Work Order ID 96432

Item ID: D350-689-021 Accept ***N900040100*** Setup Start ***NS1***
 Revision ID: Stop ***NS2***
 Item Name: Dual High Back Seat, LH
 Start Date: 1/28/13 Start Qty: 1.00 ***1*** Cust Item ID:
 Required Date: 2/22/13 Req'd Qty: 1.00 ***1*** Customer:
 Reference:

B	CHANGES TO -013 KIT INSTALLATION. REF: CIR12-12.	MB	12.11.09
A	NEW ISSUE	MB	11.12.22
REV.	DESCRIPTION	BY	DATE
DESIGN		DART AEROSPACE LTD	
DRAWN		HAWKESBURY, ONTARIO, CANADA	
CHECKED		DRAWING NO.	REV. B
MFG. APPR.	N/A	DSI 9588	SHEET 1 OF 6
APPROVED		TITLE	SCALE
DE APPR.		INSTALLATION CHANGE	NTS
DATE	12.11.09	COPYRIGHT © 2011 BY DART AEROSPACE LTD	
THIS DOCUMENT IS PRIVATE AND CONFIDENTIAL AND IS SUPPLIED ON THE EXPRESS CONDITION THAT IT IS NOT TO BE USED FOR ANY PURPOSE OR COPIED OR COMMUNICATED TO ANY OTHER PERSON WITHOUT THE WRITTEN PERMISSION OF DART AEROSPACE LTD.

3.0 INSTALLATION CHANGES FOR D350-689-023

FIGURE 1: UPDATES TO CROSS SECTIONS F-F AND M-M

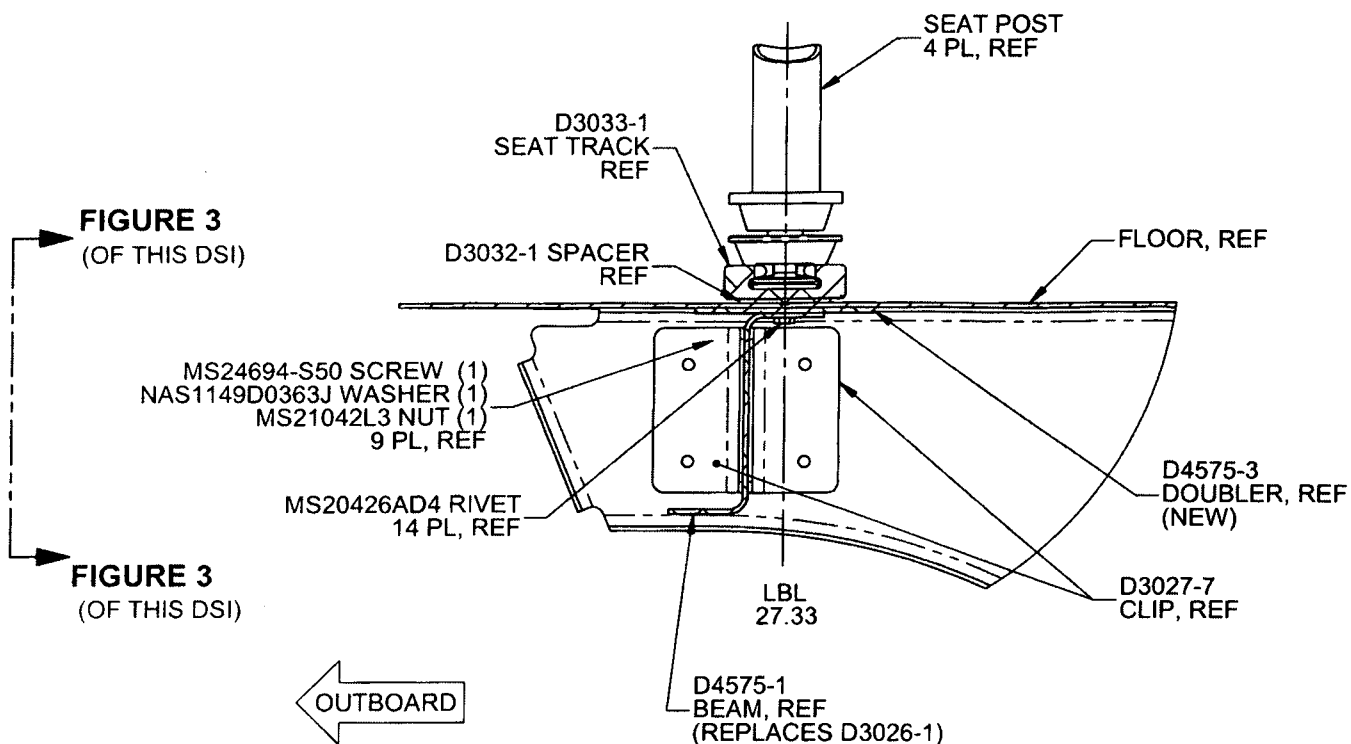
If there is an existing stringer at LBL 27.33, it will need to be removed from that location. Locate D4575-1 Beam and D4575-3 Doubler as shown in Figure 2 of this Service Instruction. Transfer drill existing holes from the aircraft floor to the D4575-1 Beam and D4575-3 Doubler. Ensure 1.0" to 1.5" rivet pitch and add additional holes if required. If there is no existing stringer, locate D4575-1 Beam and D4575-3 Doubler as shown in Figure 1 of this Service Instruction and drill Ø0.128" holes on a 1.0" to 1.5" pitch.

With reference to Figures 5 and 7 of IIN-D350-689
 (Figures 25-5 and 25-7 of ICA-D350-689)

FIGURE 2: UPDATES TO FIGURE 21 (IIN-D350-689) AND 25-21 (ICA-D350-689)

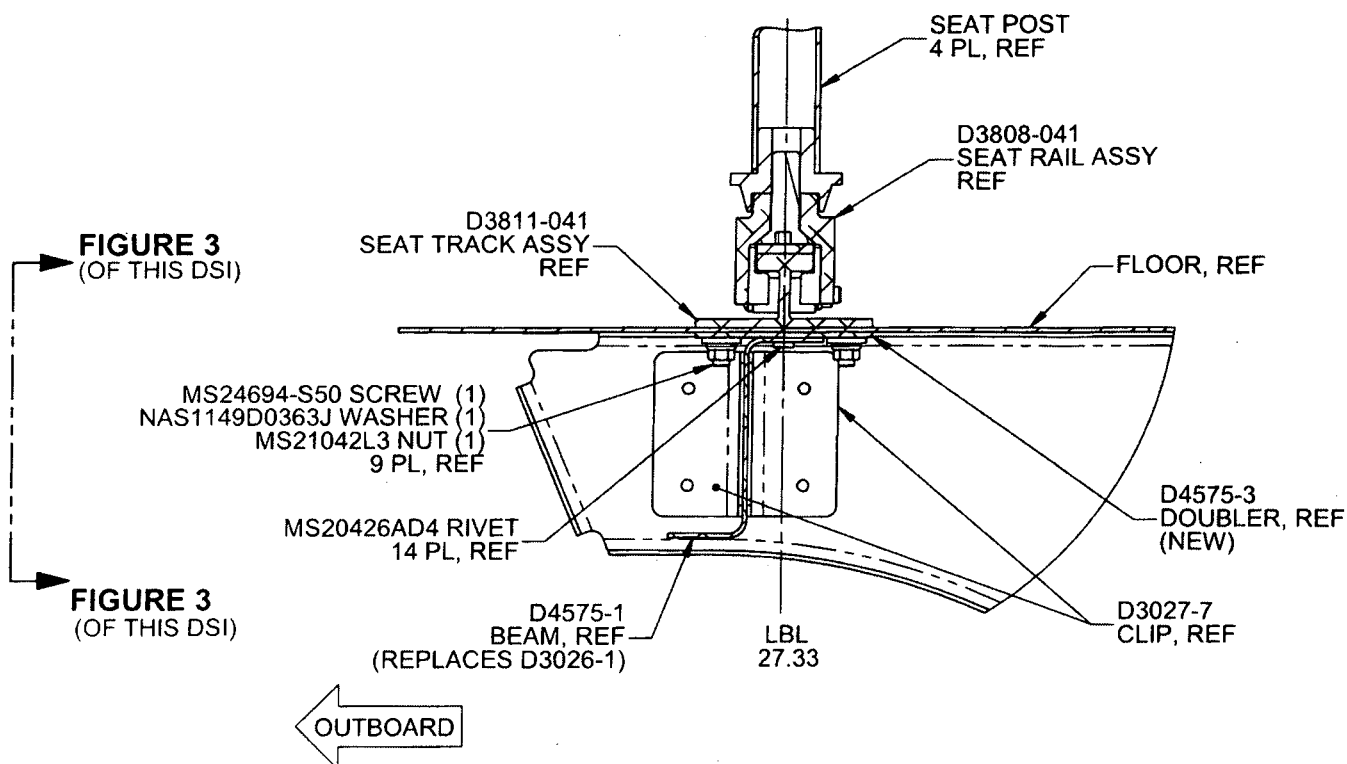
FIGURE 21: Cross Section View T-T from Figure 19 (IIN-D350-689)
FIGURE 25-21: Cross Section View T-T from Figure 25-19 (ICA-D350-689)

With reference to Figures 19 and 20 of IIN-D350-689
 (Figures 25-19 and 25-20 of ICA-D350-689)

FIGURE 3: RELIEFS ON D4575-1/-3
(ONLY D4575-1/-3 SHOWN FOR CLARITY)
VIEW LOOKING INBOARD

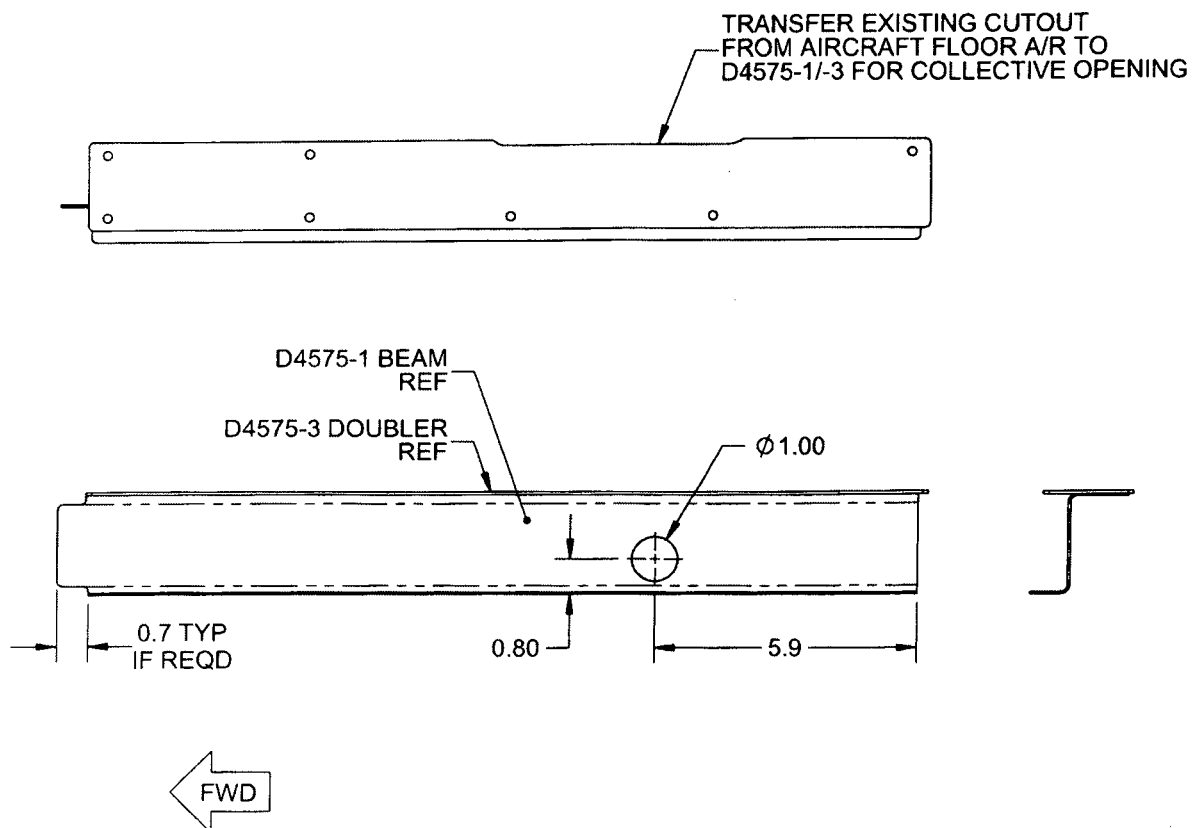
Note: Drill a Ø1.00" (Ø25.4 mm) hole in the D4575-1 Beam to clear extension tube of collective and cutout as required for clearance of collective opening and fwd bulkhead as shown in Figure 3 of this Service Instruction.
